## CITY OF BELOIT REPORT TO THE BELOIT LANDMARKS COMMISSION

Meeting Date: February 17, 2009	Agenda Item: 4	File Number: COA-2009-03
Applicant: Matt Ruch	Owner: Matt Ruch	Location: 1023 Chapin Street
<b>Existing Zoning:</b> R-1B, Single-Family Residential District	<b>Existing Land Use:</b> Multi-Family Dwelling (3 units)	Parcel Size: Approx. ¼ acre

Matt Ruch has submitted a Certificate of Appropriateness (COA) Application to replace three exterior doors and to tuck point the chimney on the building located at 1023 Chapin Street. The attached *Location and Zoning Map* shows the location of the property involved in this application. The property is located on the northwest corner of the intersection of Wisconsin Avenue and Chapin Street. This property is located within the College Park Historic District.

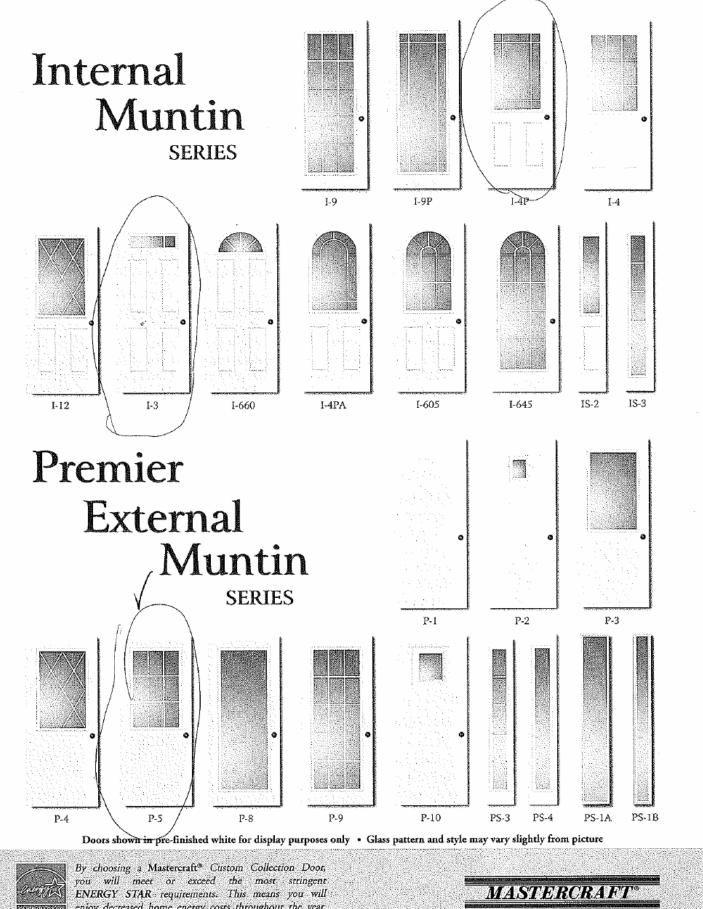
- The applicant has not proposed a change in the size of any of the door openings.
- The applicant has submitted a manufacturer's pamphlet and has identified three potential door styles. Staff feels that style "P-5," which is shown on the attached pamphlet and on the handout, is the best option.

Staff recommends the installation of door style "P-5," which closely matches the existing doors in terms of window pattern and appearance. Door style "P-5" is compatible with the character of this historic structure.

- 1. All three new doors shall be Mastercraft "P-5" doors.
- 2. The chimney shall be tuck pointed in accordance with the Secretary of the Interior Standards. The chimney shall retain the existing color and design.
- 3. All work shall be completed by December 31, 2009.
- 4. Any changes or additions to this Certificate of Appropriateness must be reviewed and approved by staff prior to the start of any work. Work done without prior approval will be subject to the issuance of correction orders or citations.
- 5. The applicant must obtain all necessary building permits. The completion date above does not extend any other time limits, such as those imposed by an order from Housing Services.
